# PERMIT

SEWAGE DISPOSAL SYSTEM

ROAD 7250 Meadow Wood Way LOT 5 Sec. 2

Re: Failing Septic System Notice  
7250 Meadow Wood Way  
Simpson Woods, Lot 5

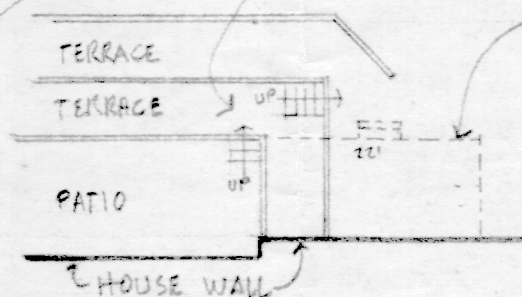
ingr. Pool in back

Existing system  
failing  
where is 10,000 \$ for  
existing house

Appears excavation  
in backyard - soils  
placed on existing SDA,  
Cable @ end of SDA / slightly  
in / driveway over SDA??

### LOCATION DIAGRAM

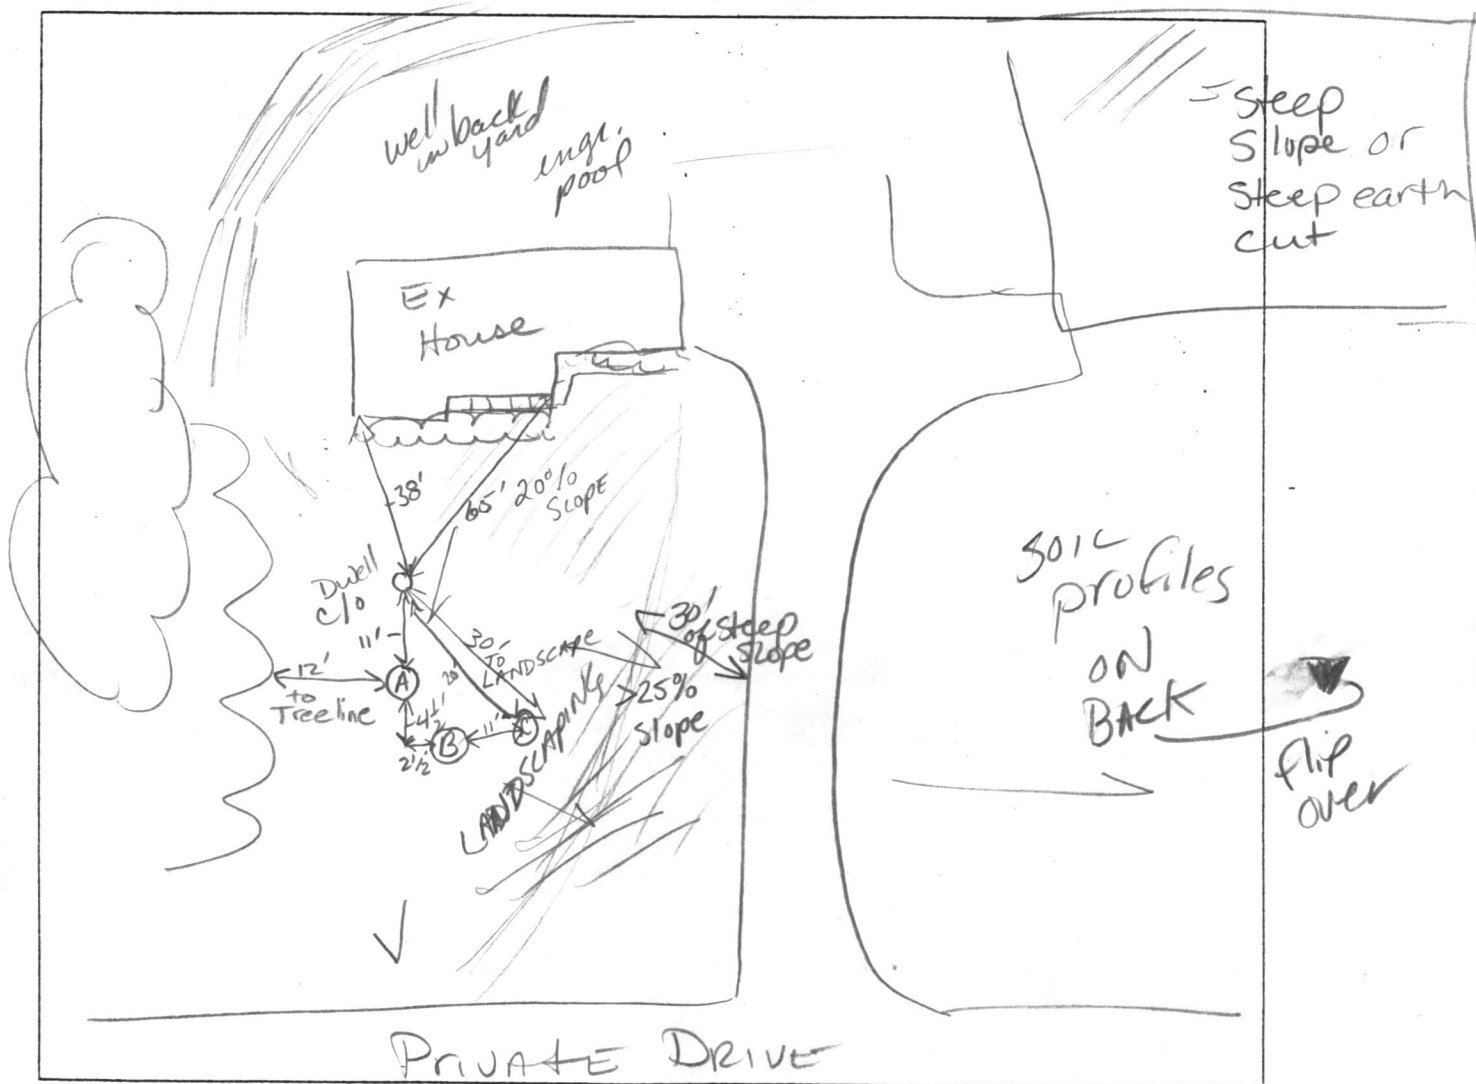
COMMENTS: 12-20-04 Percolation test holes in 1980 established septic area. However, due to excavation for driveway creating hillside w/ slopes  $>25\%$  at least 4,500 ft<sup>2</sup> has been compromised. Augered test holes today encountered shallow depths to 28" due to

DATE: 12-20-04 INSPECTOR: KN  
rock or pvc pipe? SEE SOIL DESCRIPTIONS EFFluent in dry well @ low level  
EST 26'

Angered in area  
of visible surface  
B / (A)

Frozen 3"  
brn  
wk rdbn  
micaceous  
granular  
Loam  
12"  
rd brn  
micae  $\approx 40\%$   
SL  
↓  
22"  
grey black  
dk brn  
rock  
frag  
organic  
in appearance  
No roots in  
this layer  
2mm thick +  
size of silver  
dollar  
LOAM  
26"  
tan  
wk rdbn  
moist  
Loam  
28"  
refusal -  
pvc pipe??  
hit hard surface  
sounds hollow

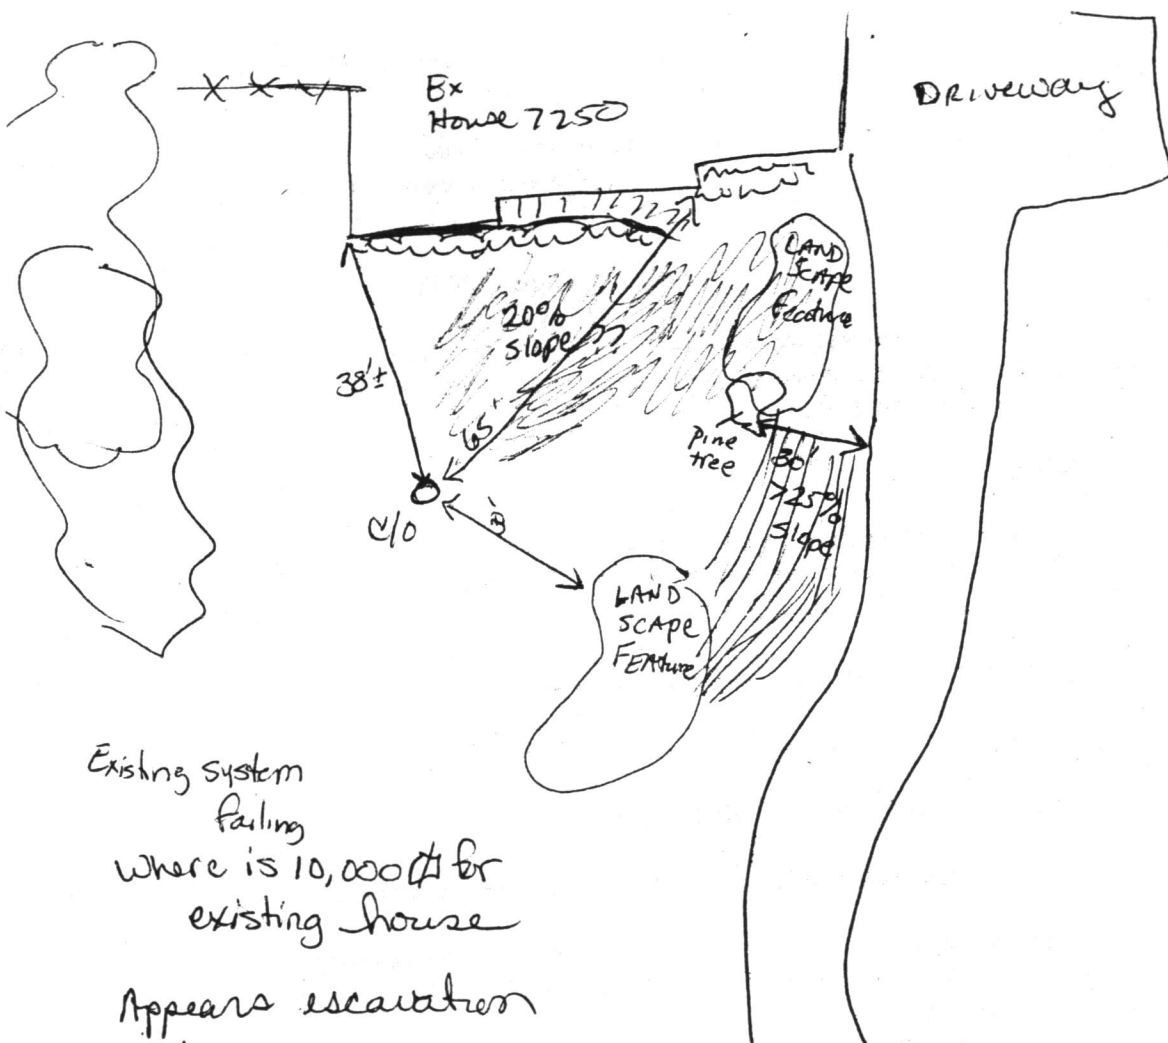
Angered hole out of wall ...  
20' from dry well c/o  
11' from hole (B)  
(C)

brn, tan,  
wk rdbn, 30-  
v. micae 40%  
Loam  
23"  
tan rdbn  
SL  
mica 45%±  
1 stone frag  
encountered  
28"  
Hard Rock?  
Sounded hollow,  
though.

ingr. pool in back

Existing system  
failing  
where is 10,000 \$ for  
existing house

Appears excavation  
in backyard - soils  
placed on existing SDA,  
Cable @ end of SDA / slightly  
in / driveway over SDA??
